Response to Comment PC323-78

5.4. Proposed Land Swap with the California State Lands Commission

Photograph PC333-4 - View from the sidewalk on Anita Street/Herondo Street west of Prospect (#4 on the Key Map above)

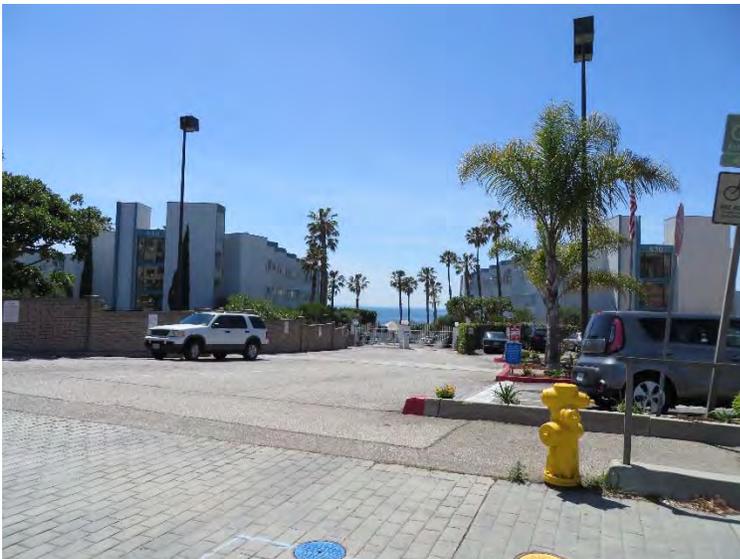
The commenter also suggests an analysis of views along Anita Street/Herondo Street. Anita Street/Herondo Street is located at its closest point 0.5 mile north of the project site. Views of the water are available from Anita Street/Herondo Street from approximately Prospect Avenue west (see Photograph PC333-4). From approximately Prospect Avenue, there is view of the harbor area (including but not limited to the project site) and Pacific Ocean. Power lines and the AES Power Plant are also central visual features at this location that reduce the overall quality of the view. The proposed project is at a lower elevation than much of the existing development (i.e., the condominiums located west of Catalina Avenue, Crown Plaza Hotel at Beryl Street and Harbor Drive, and the AES Power Plant on Harbor Drive south of Herondo Street which are visible from some locations along Anita Street) and as such, the development associated with the project would not be visible or distinguishable from other development in the area. From further west on Anita Street/Herondo Street, views of the water area are of the north of the project site, and the project site is not visible. Consequently, the project would not result in a significant view related impact at this location.

The commenter also suggests an analysis of views along Catalina Avenue. As discussed under the response associated with Diamond Street, the Draft EIR included an analysis of Key Observation Views 1, 2, and 3, which are located approximately 125 feet west of Catalina Avenue and were considered representative of other viewpoints in close proximity. In this case, these Key Observation Views would be considered a worst-case analysis of views from Catalina Avenue. As can be seen in Draft EIR Figure 3.1-5, except for the view through Czuleger Park, views of the project site are extremely limited from other locations along Catalina Avenue, which are largely blocked under existing conditions by a series of approximately 25 condominium structures and associated landscaping (see Photographs PC333-5 and PC333-6 below). As shown in Photograph PC333-6 below, a portion of the top of the existing Pier Plaza roofline is visible between the condominium buildings from this location, with the water and horizon visible beyond. Under the proposed project, the maximum elevation of development at this location would be similar to the height of the existing Pier Plaza development, and therefore, views of the water and horizon above the new roofline would remain. Therefore, the views from this location would not substantially change and no significant impacts would occur. For discussion of views south of Torrance Boulevard on Catalina Avenue, see the subsequent discussion of Veterans Park.
